REMARKS/ARGUMENTS

AMENDMENTS TO THE DRAWINGS

The attached sheets of drawings include changes to Figure 2 and Figure 3. These sheets, which include Figures 1-4, replace the original sheets filed.

FIG.3

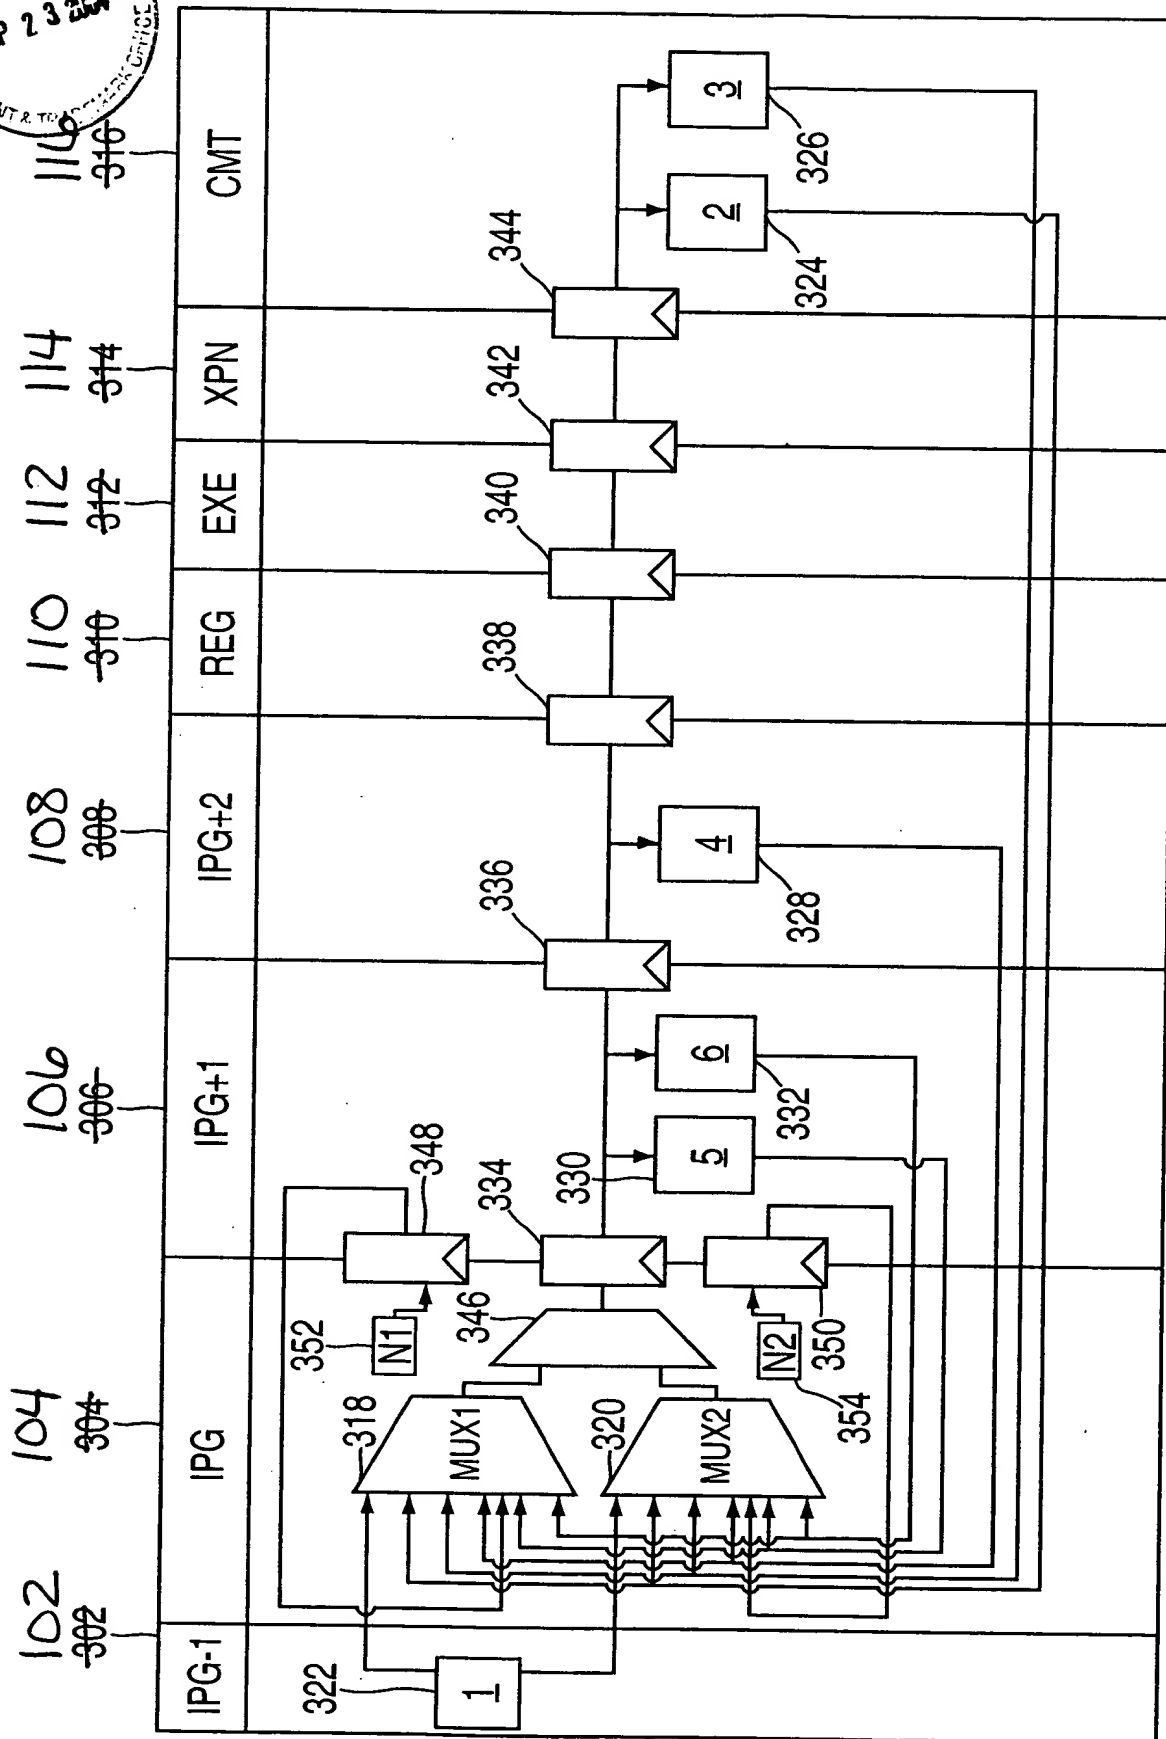
The drawings and claim 10 were objected to. The amended Figure 2 and Figure 3 are attached. Applicant is not amending Figures 2 and 3 to remove the “hop-overs”. As stated in the Office Action, “hop-overs” indicate crossing wires that are not connected. Further, the drawings are currently at the maximum size allowed under PTO guidelines. These space constraints currently dictate keeping the wires at their current spacing. Increasing the spacing would cause crowding of other areas of the figure, likely causing an increase in confusion and not a decrease. The drawings currently have enough spacing in their present incarnation to accurately separate out the different wires and to differentiate between the connections. A complete replacement set of drawings is also enclosed. Claim 10 has been amended to overcome the Examiner’s objection.
